Product Change Notification: SYST-25GKII385

dsPIC33CDVL64MC106 Family Silicon Errata and Data Sheet Clarification

SYST-25GKII385

dsPIC33CDVL64MC106 Family Silicon Errata and Data Sheet Clarification

Figure 1: Wake Extender Circuit

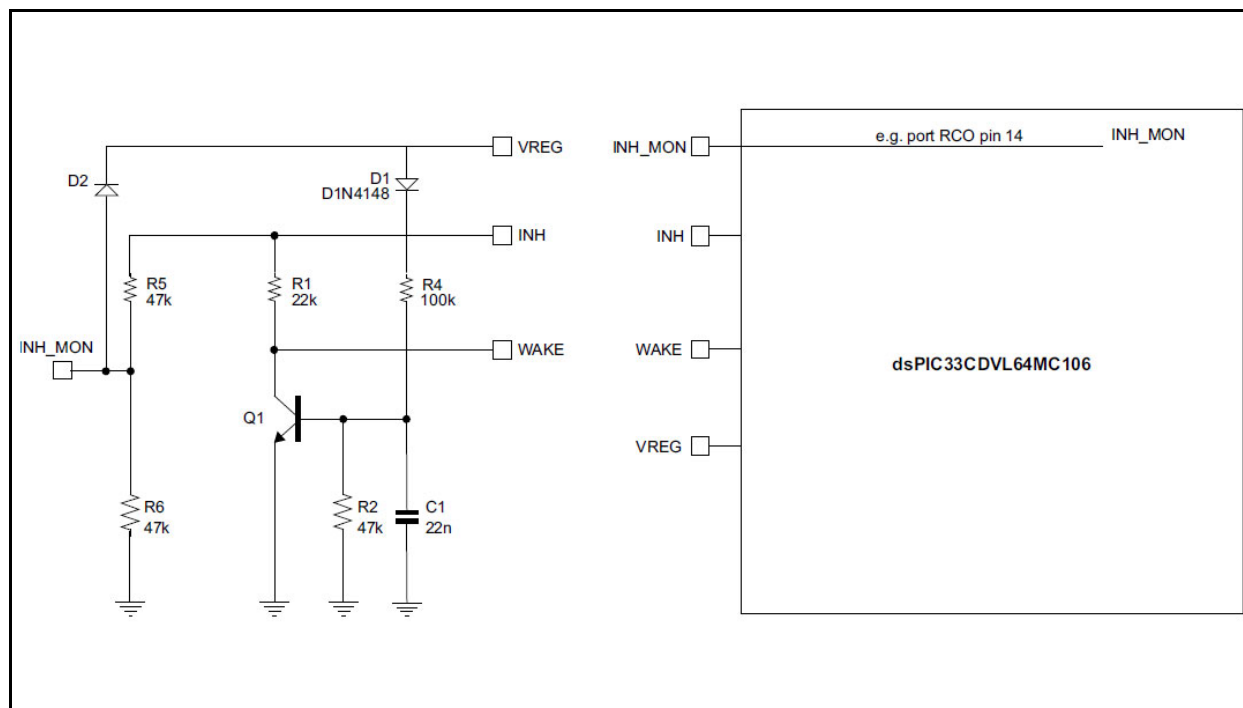
When utilizing the VREG output of the MOSFET Gate Driver module to power the host processor and relying on LIN Transceiver bus activity to generate a wake-up event, a timing conflict may occur. If the MOSFET Gate Driver is in Sleep mode, the edge from the LIN_INH output that triggers the wake event may fail to be detected by the MOSFET Gate Driver. This situation occurs if the incoming rising edge happens before the setup time required to put the MOSFET Gate Driver into Sleep mode has been satisfied. This could lead to the gate driver not waking up as expected.

Implement the external HW circuit and SW routine below to delay any incoming rising edge on the WAKE pin $\geq t_{\text{SLEEP}} + t_{\text{WAIT_SETUP}}$.

In conjunction with the additional hardware in Figure 1, the node labeled “INH_MON” should be utilized as an input to the dsPIC DSC to monitor the state of the LIN Transceiver module to ensure the LIN device is in Sleep mode prior to sending the Sleep command to the gate driver. Since INH_MON is a product of LIN_INH, it will be low when LIN_EN is set low. After INH_MON is confirmed to be in a Low state via software, the host dsPIC DSC can proceed with putting the gate driver to sleep after tSLEEP_MIN has elapsed. Figure 2 shows a block diagram of the recommended software flow. See sections Section 17.1.6, Enable Input Pin (LIN_EN) and Section 17.1.7, Inhibit Output Pin (LIN_INH) in the data sheet DS70005441E for details on the functionality of pins LIN_EN and LIN_INH for the LIN Transceiver.
